Product change information (PCN)

PCN No.:	AAC170034	Date:	26.02.2018
Product:	HSCP-SP

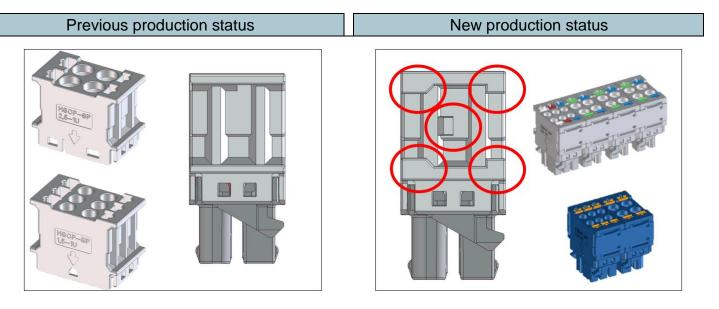
Description of changes						
⊠ Product appearance (fit)	Product geometry (form)	Product function (function)				
Function extension regarding the ME-IO housing: individual connectors are grouped together						
to form a block						
The front connection technology of the ME-IO housing system allows individual HSCP-SP connectors to be						
removed. To achieve more flexibility in the ME-IO module design, it should be possible to combine individual						
connectors with each other. Overall connectors are created in this way offering a higher number of poles for

connectors with each other. Overall connectors are created in this way offering a higher number of poles for the application. To this end, a block belt has been designed that enables individual connectors to be grouped together in order to form an overall connector. The side contour of the individual connector (not visible when installed) will be adapted on both sides to match the contour of the block belt.

The dimensions of the connectors remain unchanged and they can still be used as individual connectors.
